ADA Curb Ramp New Construction Inspection Form (Parallel)

Nw. Glencoe rd.

24952.54

Nw pacific st.

PARALLEL RAMP (PL)

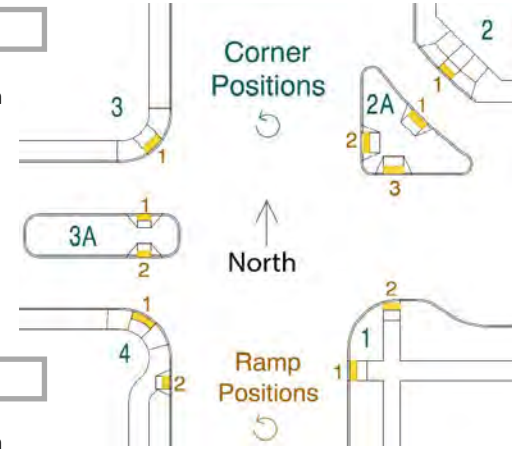
2.5 \leq 2.0% ☐ $>$ 2.0% ☒

2.5 \leq 2.0% ☐ $>$ 2.0% ☒

IITD, cut domes in center of ramp.
